# ANSELMI ACRES

# Improvement Plans WEBER COUNTY, UTAH

TWW Comments are given on individual sheets

**Comment Response** 08/07/2023

**Sheet 2 - Notes/Legend/Street Cross-Section**

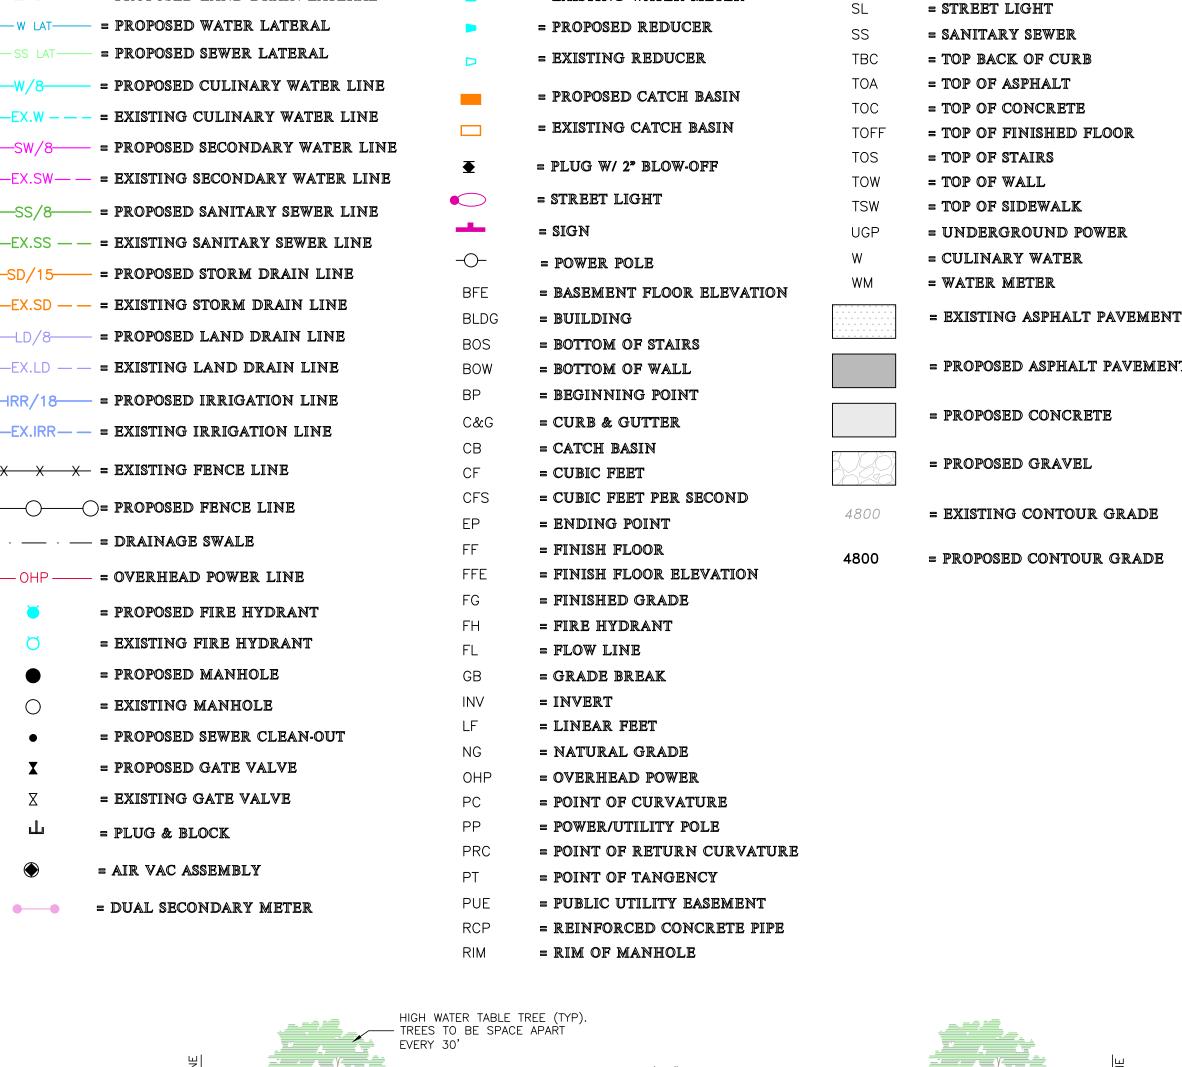
culinary water

o the Taylor-West

and Specification

eber Water

cilities shall confor

rovement District

ms unique to culinary water can be

ninated from these notes as long as the

note about conformance to TWW standards

Indard Drawings

**R&A Response:**

Notes revised.
